Service Bulletin

Bulletin No.: 20-NA-121

Subject: Water Leak at Roof Area, Various Electrical Issues, No Start, Stall, Brake Lamp Not Off, Radio Inoperative, Remote Key Inoperative, Malfunction Indicator Lamp (MIL) Illuminated

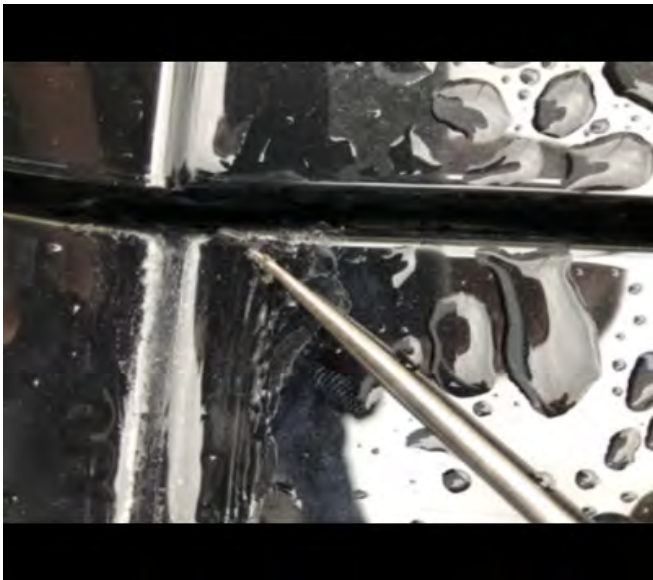
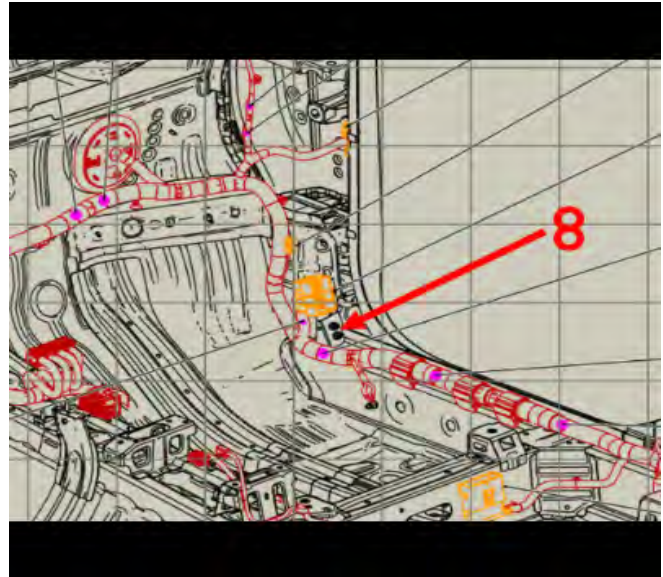
If you encounter a vehicle with the above condition, you must also include an inspection of the connectors in the water path. Inspect both the A and B-pillar interior trim and in-line connectors under the instrument panel (IP) for signs of a water leak at front roof and the rear cargo interior trim, headliner, and spare tire area for signs of a water leak at rear roof.

Once the damage is repaired, apply seam sealer along the roof to body seam to correct the condition.

Inspect and Clean Body-IP Inline Connectors and Seat Belt Retractor Pretensioners

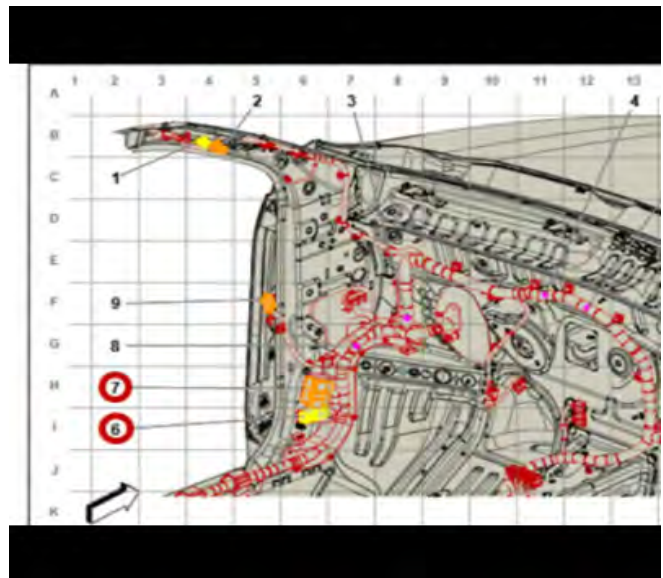
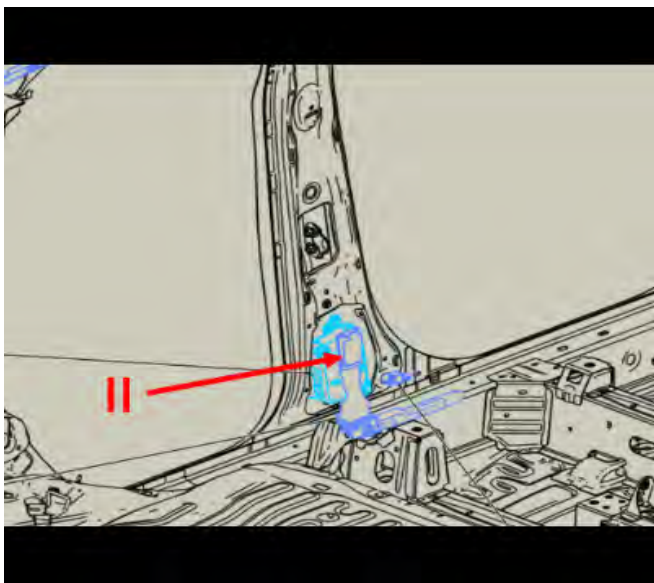
(#8) — X204 Instrument Panel Harness to Body Harness, 76-way connector right side

(#6) — X202 Instrument Panel Harness to Body Harness, 2-way connector left side

(#7) — X200 Instrument Panel Harness to Body Harness, 76-way connector left side

(#11) — F112D Seat Belt Retractor Pretensioner - Driver

(#4) — F112P Seat Belt Retractor Pretensioner – Passenger (not shown)

Clean the water inside of the connector and apply NYOGEL on terminals for waterproofing.

3. Inspect the connectors for any moisture. If needed, clean using a clean nylon bristle brush and dry connector using compressed air.
4. Preparing NYOGEL 760G (electrical grease) and flatting tool, apply on IP harness inline connector surface. Make sure all terminal pins are covered enough by grease.
5. Reattach the connectors. Make sure the 2nd locking tab is closed.
6. Reinstall the garnish trim.
